Proposed test method to establish hydrogen compatibility of materials for fuel cell vehicles

GTR no. 13 Phase 2 IWG

June 2018

Open questions and lack of consensus

3. Allowance for welds

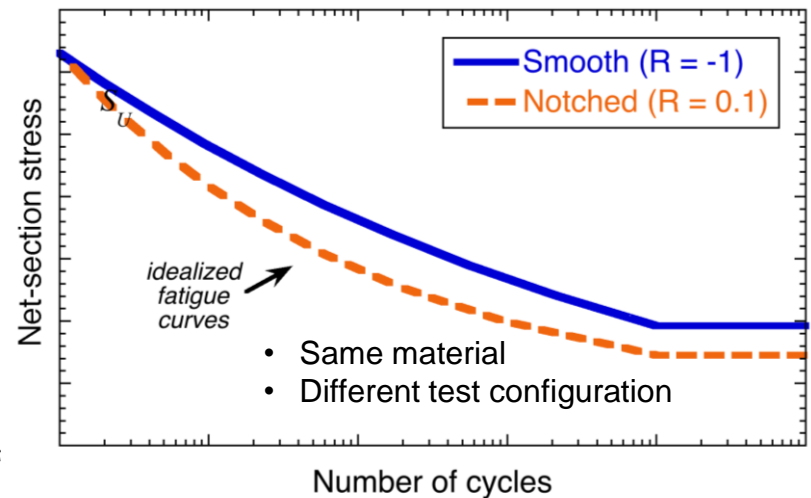
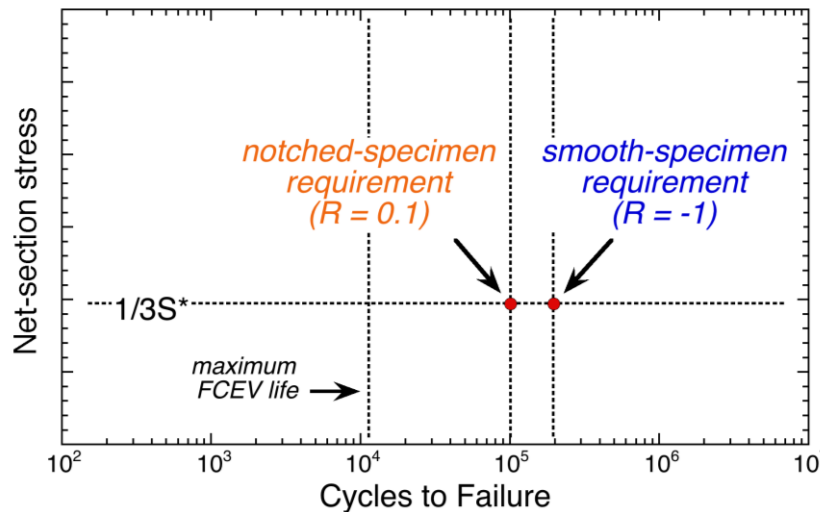
- One contracting party does not allow welds.
- Concern also about precise definition of weld and test specimens.

Technical evaluation: *relevant and addressable*

Contracting Party Question: Will welds be allowed if the technical issue is resolved?

- **Potential solutions: (two options)**
 1. provide generic performance-based language
 2. Establish prescriptive definition of welding processes and specimen extractions for all weld configurations

4. Fatigue life test options

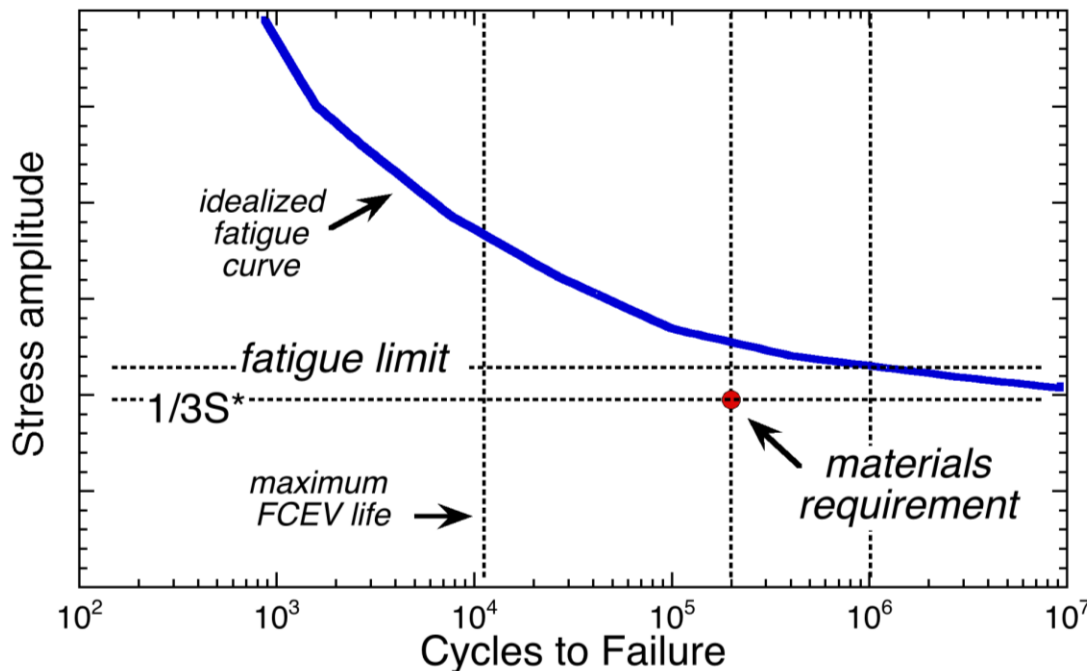
- Smooth-specimen fatigue life test: *establish that hydrogen does not change the fatigue limit*

- Maximum FCEV life = 11,000 cycles
- Materials requirement = 200,000 cycles at stress of $1/3S^*$
 - smooth specimen with $R = -1$

4. Fatigue life test options

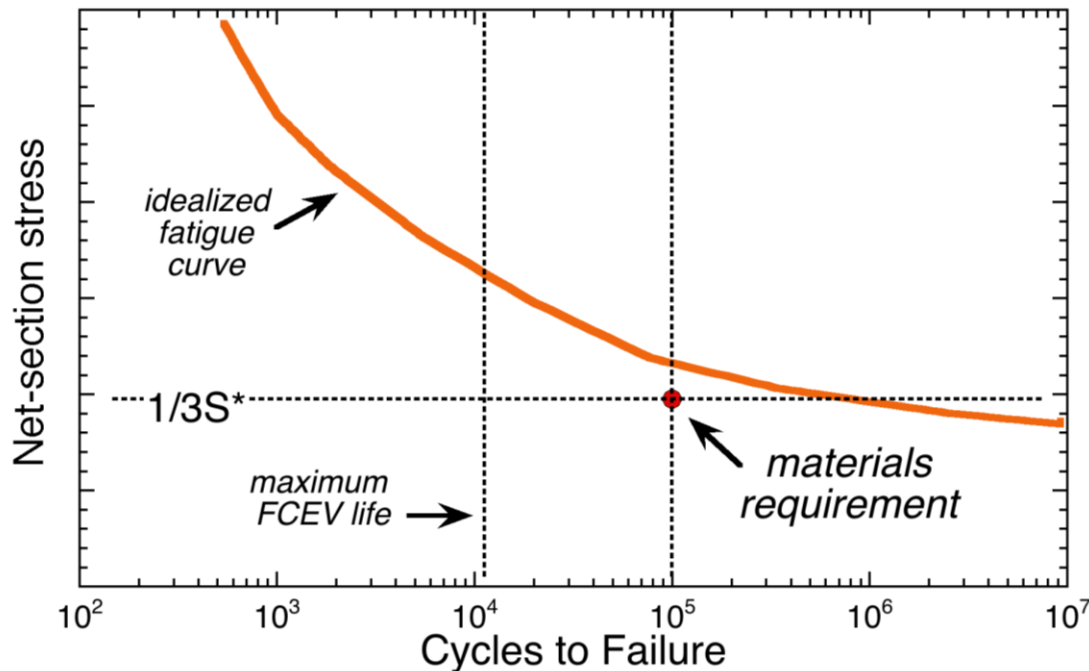
- Notched-specimen fatigue life test: *establish fatigue life 9x greater than maximum FCEV life*

- Maximum FCEV life = 11,000 cycles
- Materials requirement = 100,000 cycles at stress of $1/3S^*$
 - notched specimen with $R = 0.1$
